# ARKANSAS NUCLEAR ONE - UNIT 1

## IMPROVED TECHNICAL SPECIFICATIONS SUBMITTAL

**VOLUME 5 OF 7**

January 28, 2000

Figure 3.8.1

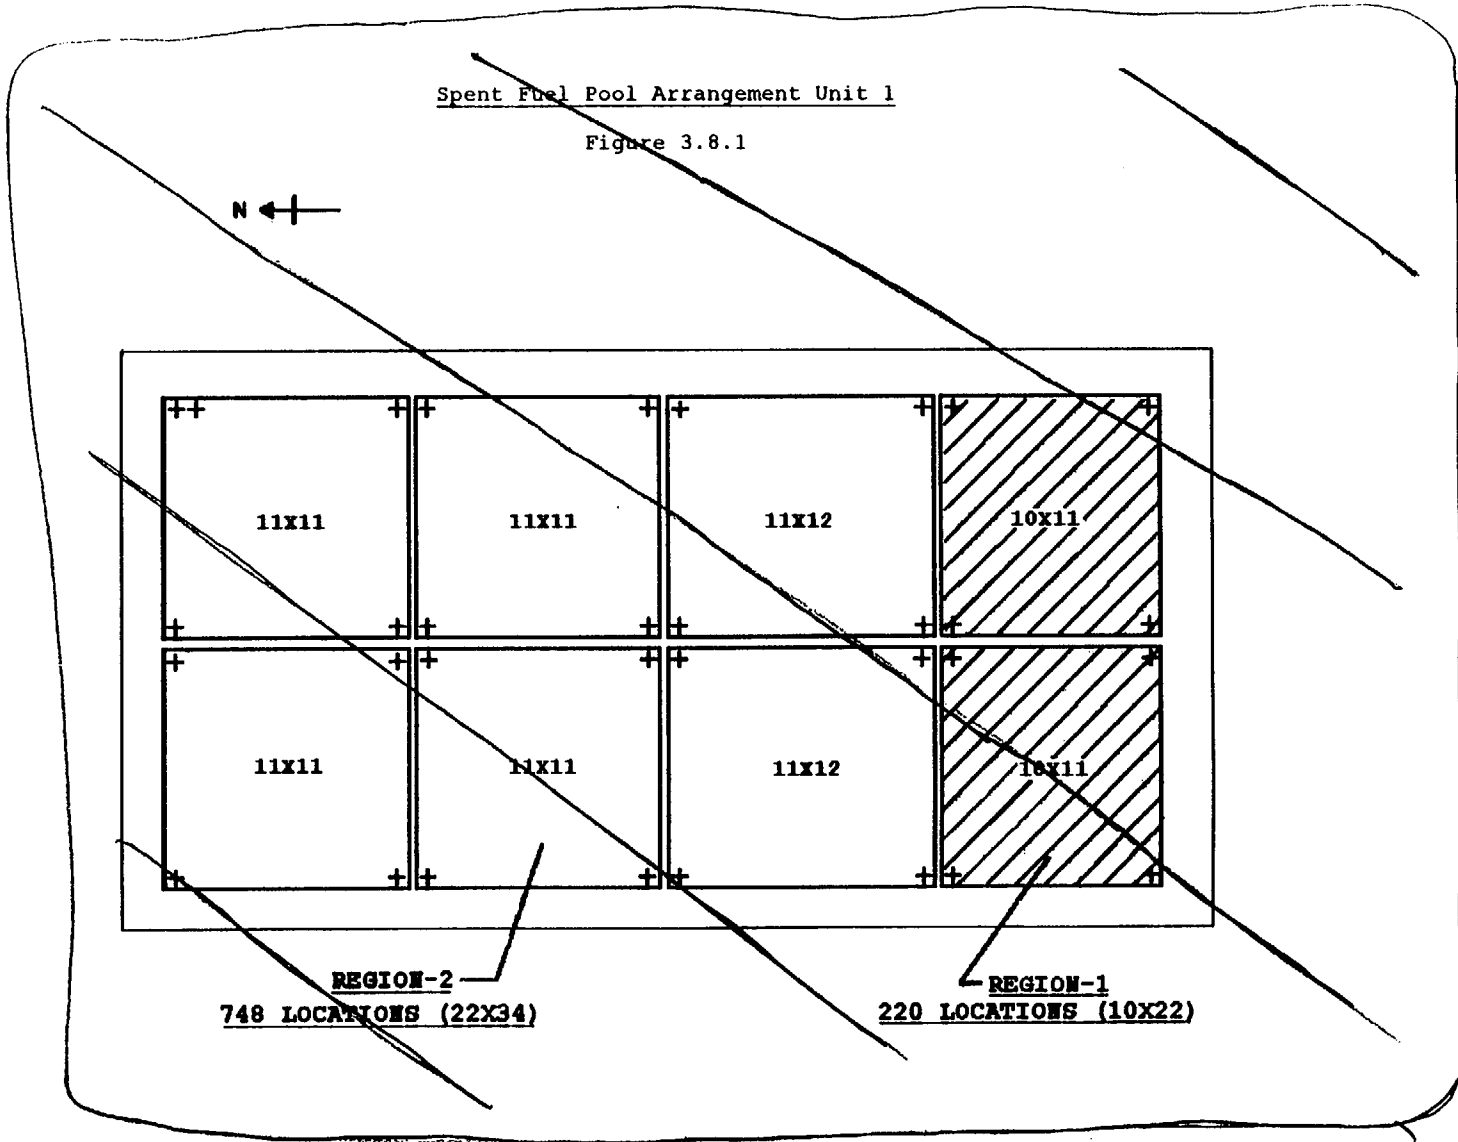
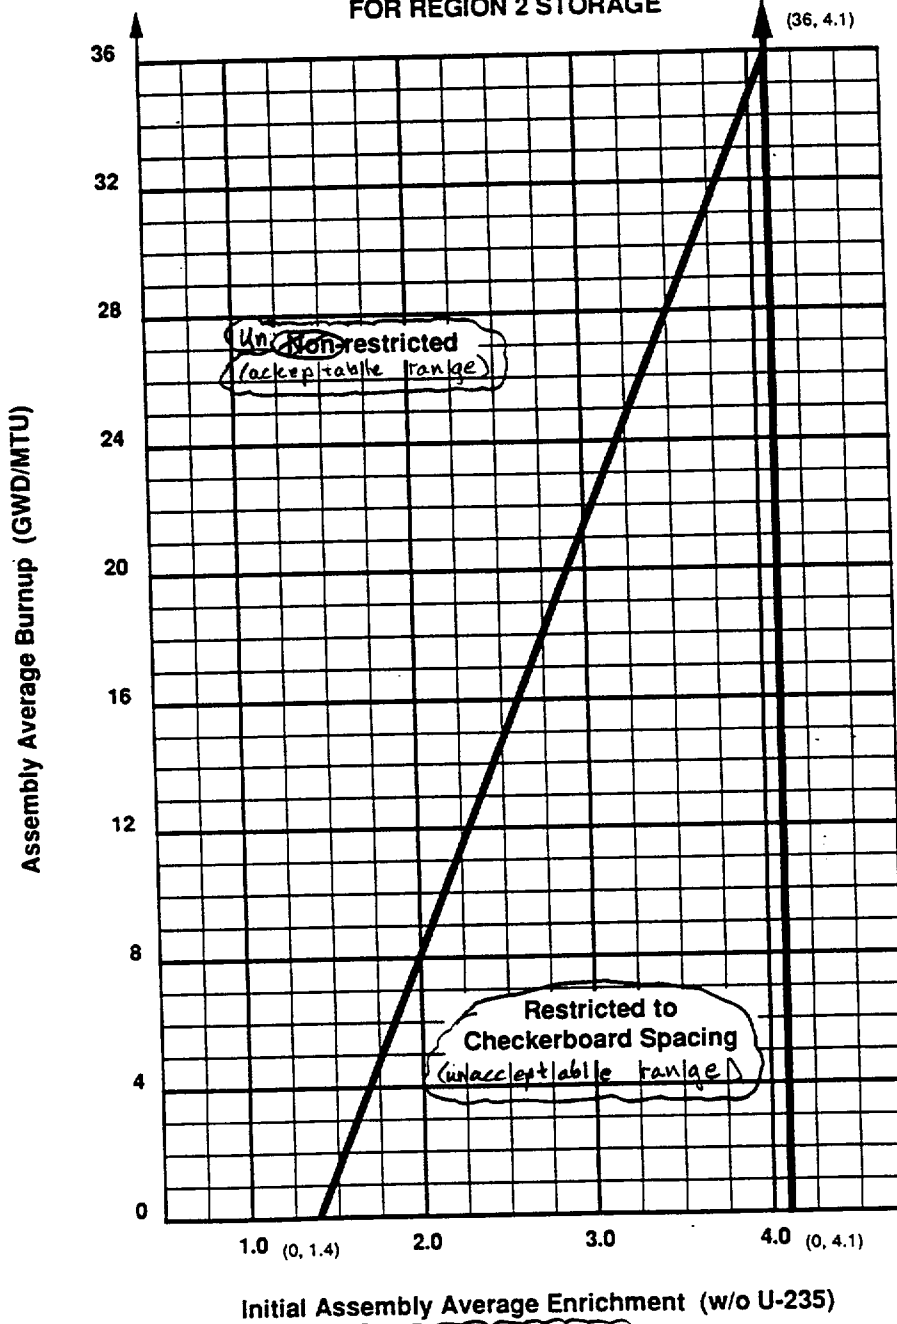
3.8.16 Storage in Region 2 (as shown on Figure 3.8.1) of the spent fuel pool shall be further restricted by burnup and enrichment limits specified in Figure 3.8.2. In the event a checkerboard storage configuration is deemed necessary for a portion of Region 2, vacant spaces adjacent to the faces of any fuel assembly which does not meet the Region 2 burnup criteria (non-restricted) shall be physically blocked before any such fuel assembly may be placed in Region 2. This will prevent inadvertent fuel assembly insertion into two adjacent storage locations. The provisions of Specification 3.0.3 are not applicable.

3.7.14

F3.7.14-1

<u>CTS Location</u>	<u>New Location</u>
3.3.1.(C)	SAR 9.3.2.1
3.8.16	SAR 9.6.2
Figure 3.8.1	SAR Fig. 9-53
3.12.1	TRM
Table 4.1-3, #4 w/Note (9)	TRM
4.5.1.1.2 (b)	TRM
4.5.2.1.2 (c) (3)	TRM
4.11.5	TRM
4.14	TRM

Figure 3.7.1-1 (page 1 of 1)  
Reduced Power and Nuclear Overpower Trip Setpoint  
versus OPERABLE Main Steam Safety Valves

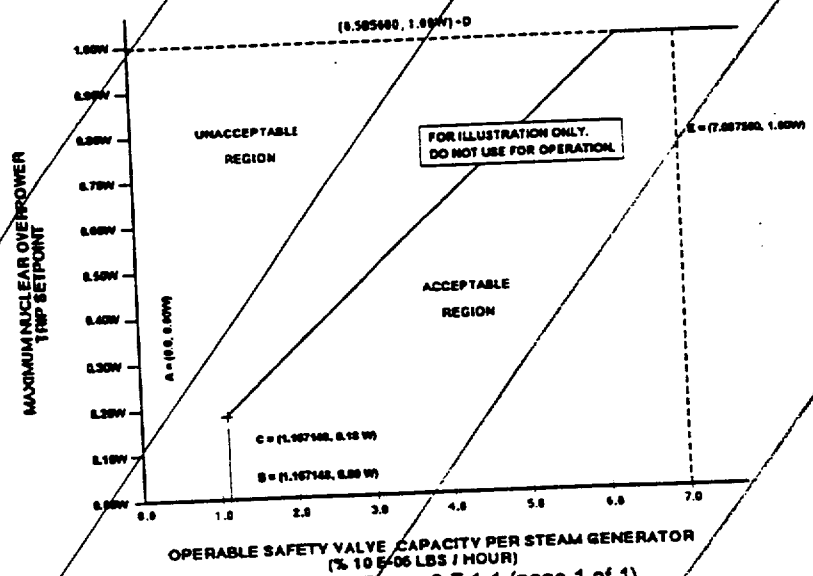
The MSSVs shall be OPERABLE on each main steam line,  
~~as specified in Table 3.7.1-1 and Figure 3.7.1-1~~

①  
NA

14  
Figure 3.7.14-1 (page 1 of 1)  
Burnup versus Enrichment Curve for  
Spent Fuel Storage Racks

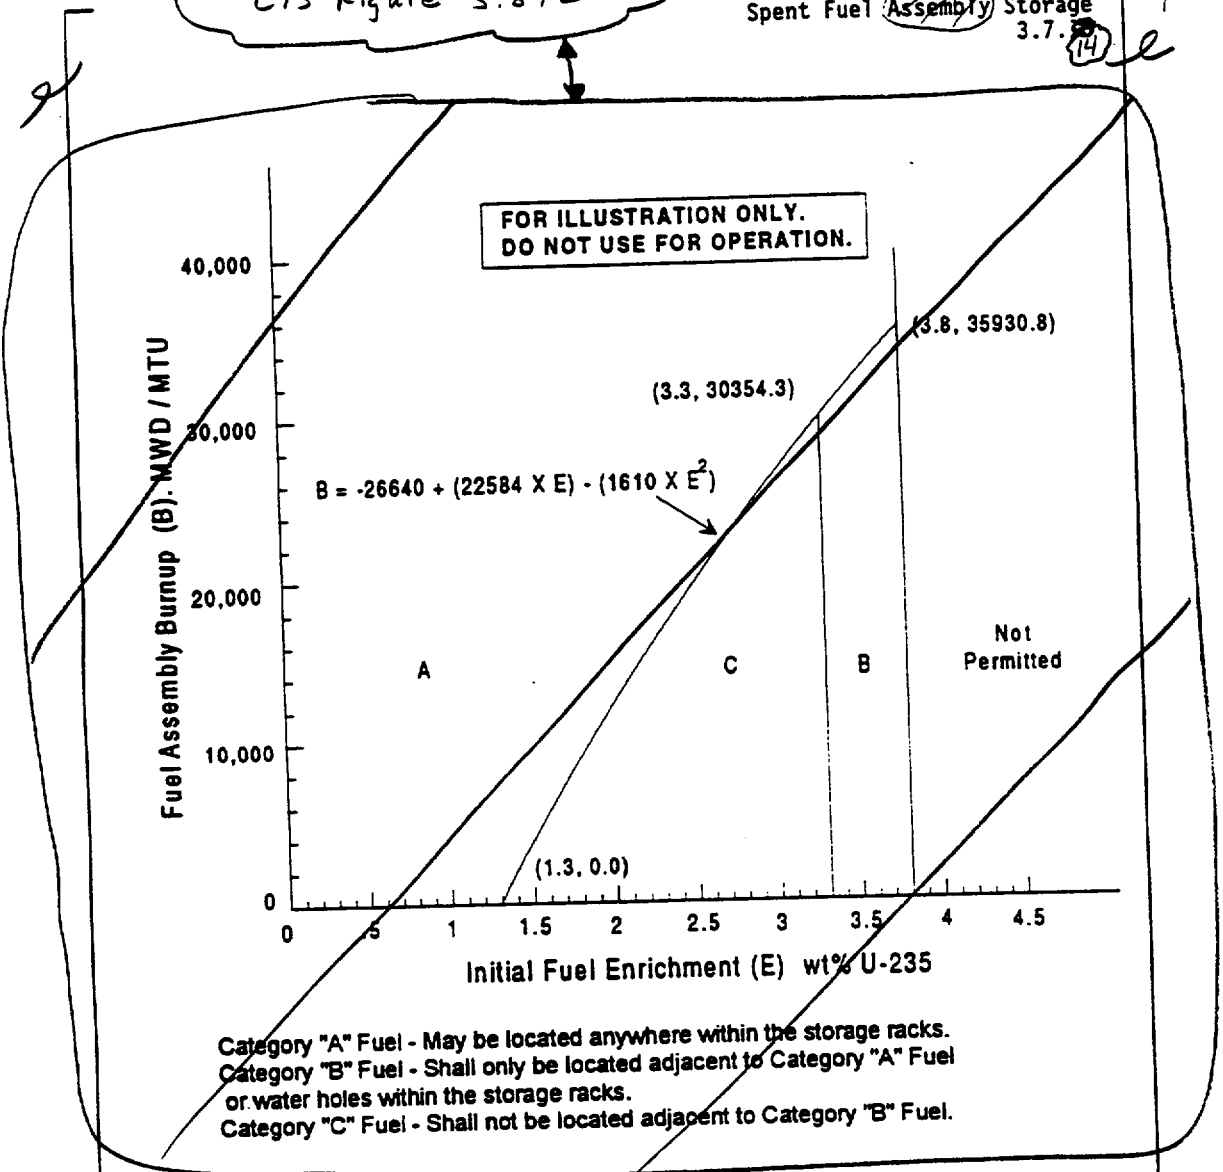
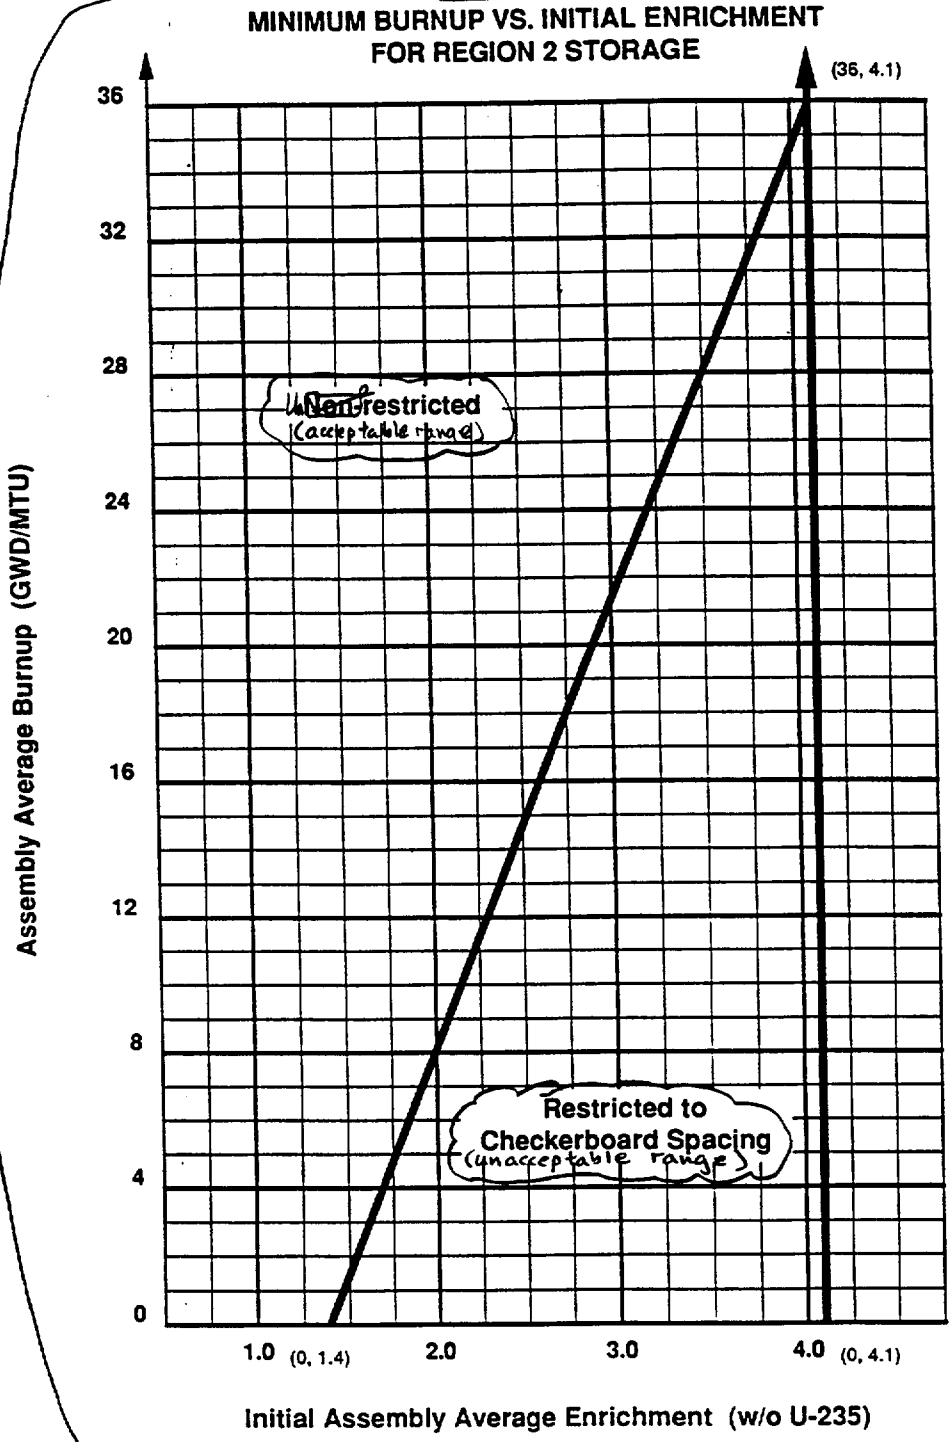
(INSERT 3.7-37A)

Replace with AND-1  
CTS Figure 3.8.2

LCO 3.7.16 14 The combination of initial enrichment and burnup of each spent fuel assembly stored in Region 2 shall be within the acceptable burnup domain of Figure 3.7.16-1 or in accordance with Specification 4.3.1.1. 14
